**RANCHO SECO NUCLEAR GENERATING STATION  
UNIT NO. 1**

**PRELIMINARY SAFETY ANALYSIS REPORT**

AMENDMENT NO. 1

AMENDMENT NO. 2

FIGURE 1A.2-1  
 HIGH BURNUP IRRADIATION PROGRAM  
 SCHEDULE (BASED ON BAW-TM-192)

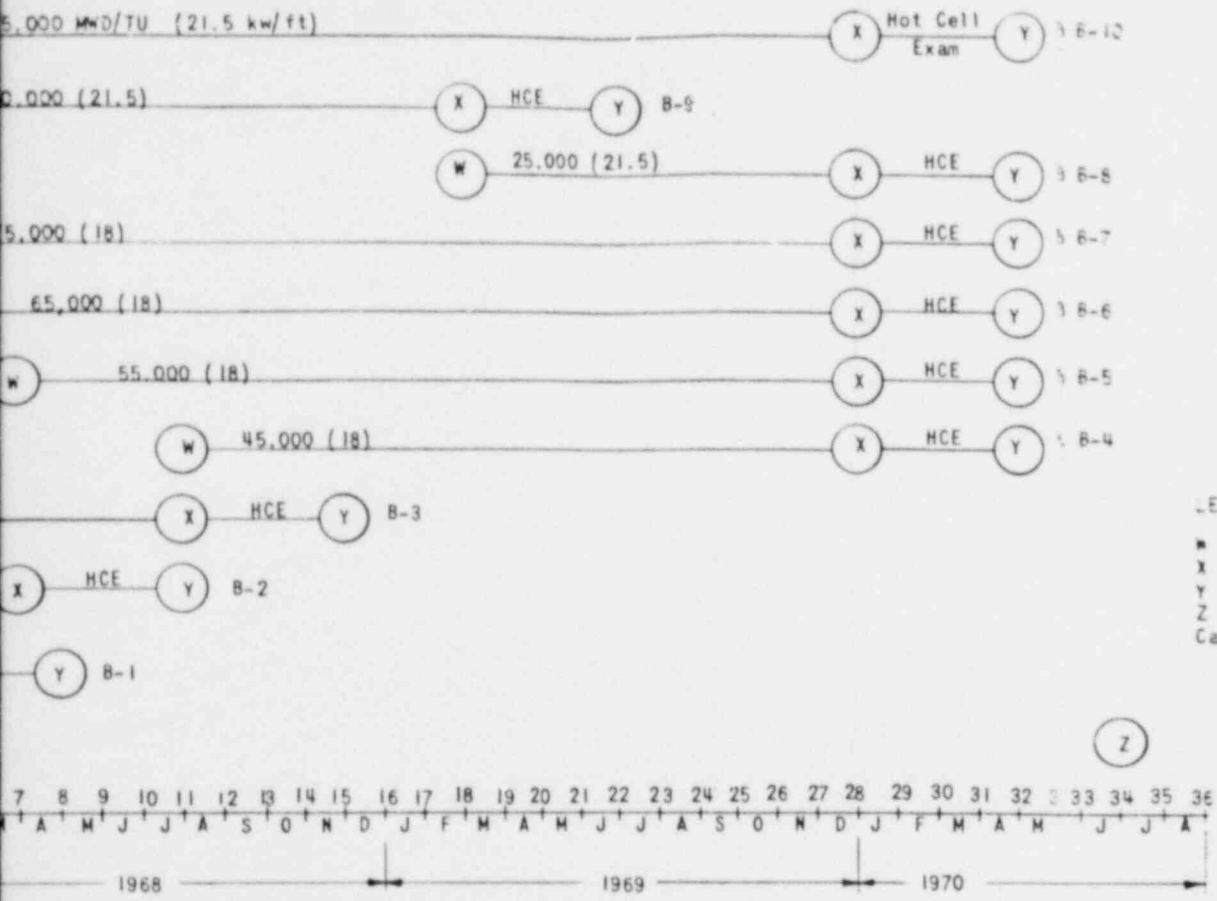
ANSWER

A high burnup fuel irradiation test program is in progress at B&W, and is described in Question 1A.2-5, Appendix 1A of the PSAR. A schedule for the program is shown in Figure 1A.2-1. This program includes fuel specimens with representative cladding thickness, fuel-clad gaps and UO<sub>2</sub> densities. Heating rates are representative of maximum heating rates and temperatures in the core. Post-irradiation examination will include profilometer scans to determine permanent clad strain, fission gas release, metallographic examination of fuel and cladding, and confirmation of burnups estimated from flux monitors during the test. Maximum target burnup is 75,000 MDW/MTU. Examination will be made at several stages of burnup between 10,000 and 75,000 MWD/MTU to determine the behavior of the fuel and cladding as a function of burnup.
